# Reliability Analysis Update PJM South

# Scope Change / Cost Increase

# Dominion Transmission Zone: Baseline 115kV Line #141 & #28 Rebuild

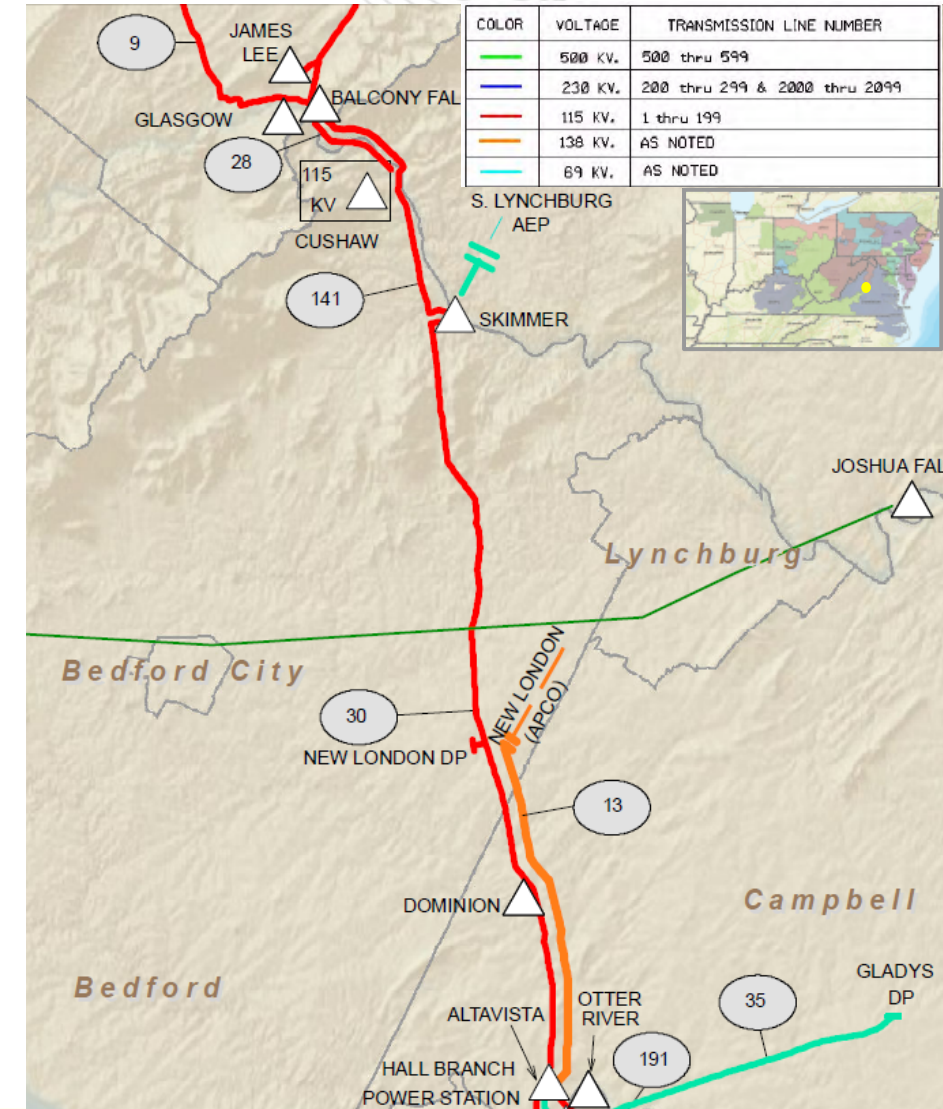
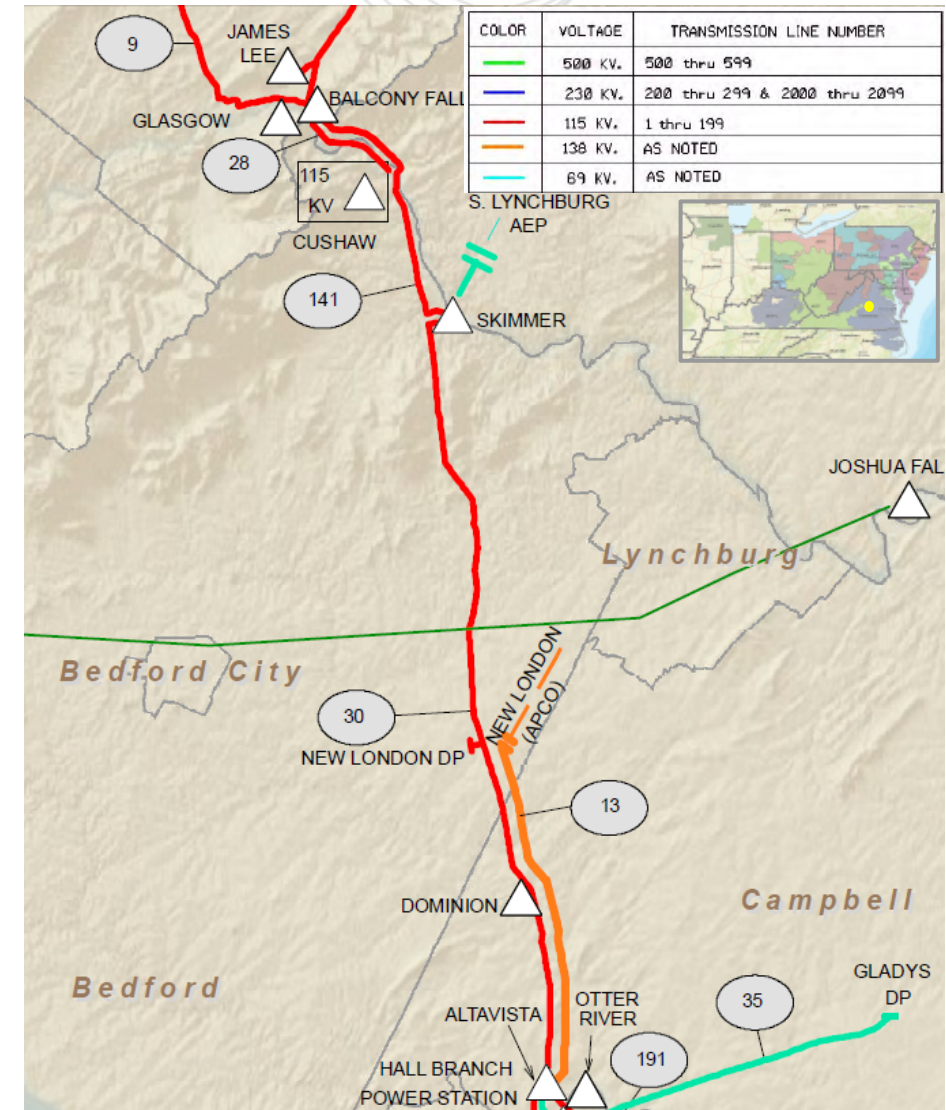
115kV Line #141 extends 9.8 miles between Balcony Falls and Skimmer. For 3.8 miles this line was constructed on a combination of double circuit Blaw Knox structures and shares with 115kV Line #28 and single circuit wood H-frame structures. Rest of line #141 is a combination of wood H-frame and Blaw Knox towers to Skimmer.

The Blaw Knox structures between Balcony Falls and Skimmer were constructed in the 1920’s, are showing deterioration, and are reaching the end of their useful service life. Wood H-frame structures for both lines are experiencing ground line deterioration, cracking, splitting, or woodpecker holes and have been identified for replacement.

Approximately 9.2 miles of Line #141 and 3.9 miles of Line #28 have 4/0 ACSR conductor that was installed in the 1920’s. Industry guidelines indicate equipment life for wood structures is 35-55 years, conductor and connectors are 40-60 years, and porcelain insulators are 50 years.

## Reason for Cost Increase:

Cost increase based on updated conceptual estimates. Cost increases take into consideration drivers such as permitting and construction.

- Replace all Line #141 and Line #28 structures and both lines will be rebuilt to current standards with a minimum rating of 261MVA. (b3098) ~~\$20M~~ **\$65M**
- Rebuild Balcony Falls Substation (b3098.1) **\$9M**

**Projected IS Date:** ~~12/31/2023~~ 5/30/2025
